ALLISON HYBRID

DPIM UPDATES

ALLISON HYBRID H 40/50 EP

Release of DPIM2

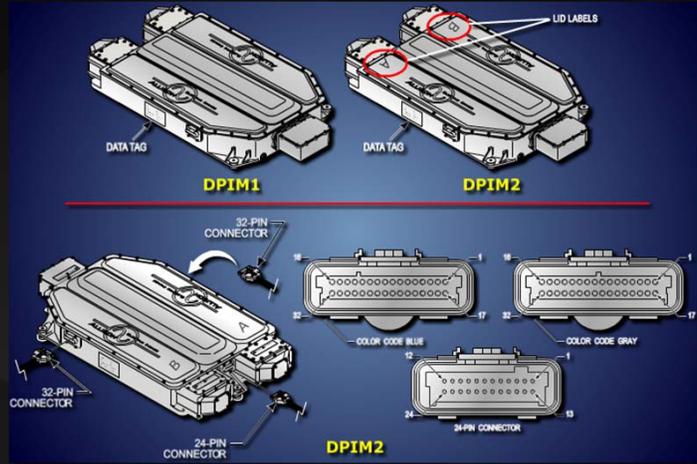
- The second generation Dual Power Inverter Module (DPIM2) was released in November 2009, beginning with serial number 7210010001.
 - DPIM2 lids include the letters A and B (corresponding to each motor) located just above the AC lug box covers.
 - The DPIM2 Motor A 32-way connector uses a blue Terminal Position Assurance (TPA) retainer rather than the red version used for DPIM1 units.

Release of DPIM2 (cont'd)

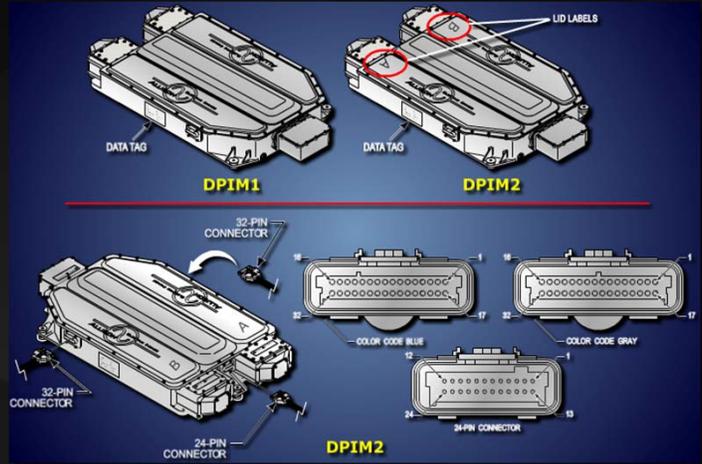
- DPIM1 and DPIM2 are completely interchangeable with an OEM wiring harness modification.
 - The red DPIM1 Motor A 32-way connector TPA is keyed differently and must be replaced with the DPIM2 blue version.
 - Wire functions and pin numbers are the same; only the keying is different between the two TPAs.

Release of DPIM2 (cont'd)

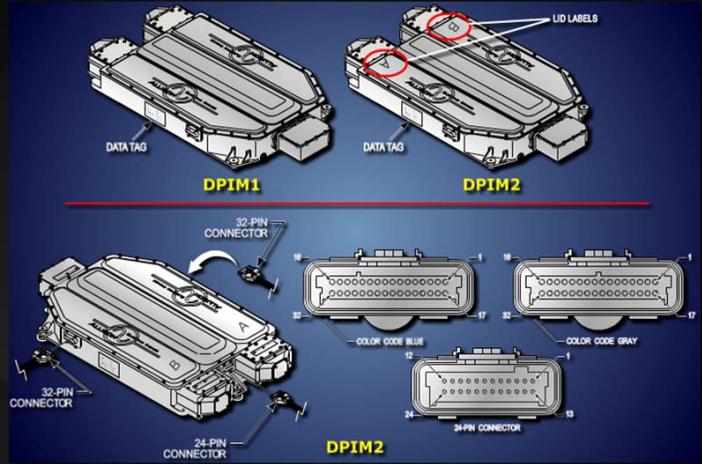
- DPIM2 units all include the updated cooler port thread design detailed in SIL 21-EP-06.
- DPIM2 uses two rather than four processors; TCM ReFlash will only display EPCU_A and EPCU_B.
- DPIM2 uses different screws to retain the high voltage cables to its bus bars (updated torque is 7-8 Newton Meters or 62-71 inch pounds).

- Reference SIL 21-EP-09 for details.

DPIM2 Special Tool and Service Kit Updates

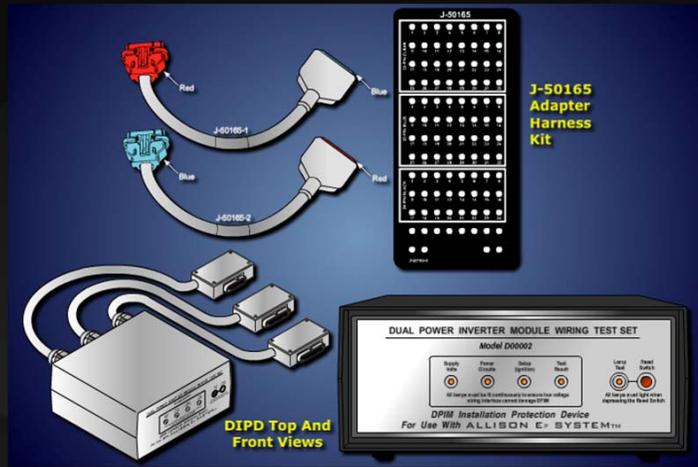
- J-46711 Breakout Harness Assembly can be utilized on DPIM2 units by using harness kit J-50165.

- *The harness kit includes two harnesses and a breakout box overlay.*
- *Use kit harness J-50165-1 and J-50165-2 to connect the breakout harness assembly to the DPIM2*
- *Use kit harness J-50165-1 to connect the DPIM Installation Protection Device (DIPD) to the DPIM2.*

NOTE: The DIPD will work with DPIM2 units but is not necessary due to a DPIM2 design change that protects the processors from shorts to battery supply and return at every pin.

DPIM High Voltage Lug Bolts

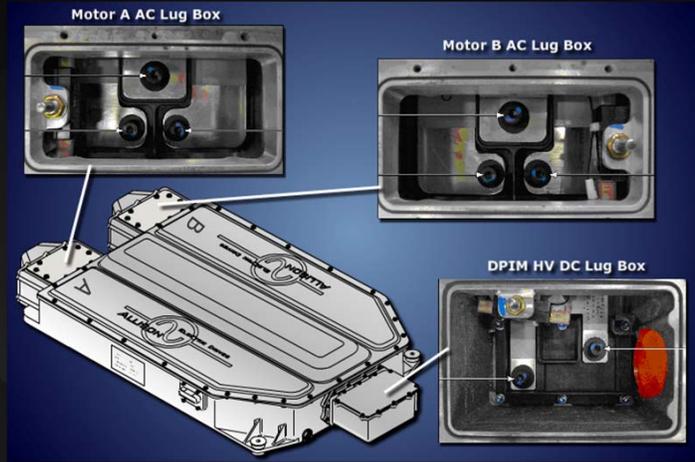
- DPIM1 uses varying fasteners for high voltage lug connection.

- Motors A and B Phase A and Phase C lugs use a 25mm long, plated lug bolt (part of kit 29541537).
- DC positive and negative lugs use a 25mm long, plated lug bolt (part of kit 29541537).
- Motors A and B Phase B lugs use a 45mm long, plated lug bolt (part of kit 29541510).
- Both kits include locking and flat washers to accompany the lug bolts.

DPIM High Voltage Lug Bolts (cont'd)

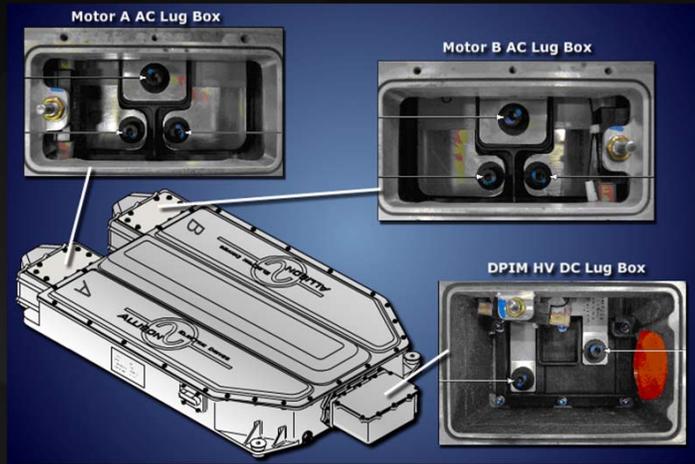
- DPIM2 uses a single fastener for all lug bolts.
 - Part number 29548555 is 29mm long with a black oxide finish and captive washers.
- Reference SIL 20-EP-10 for details.
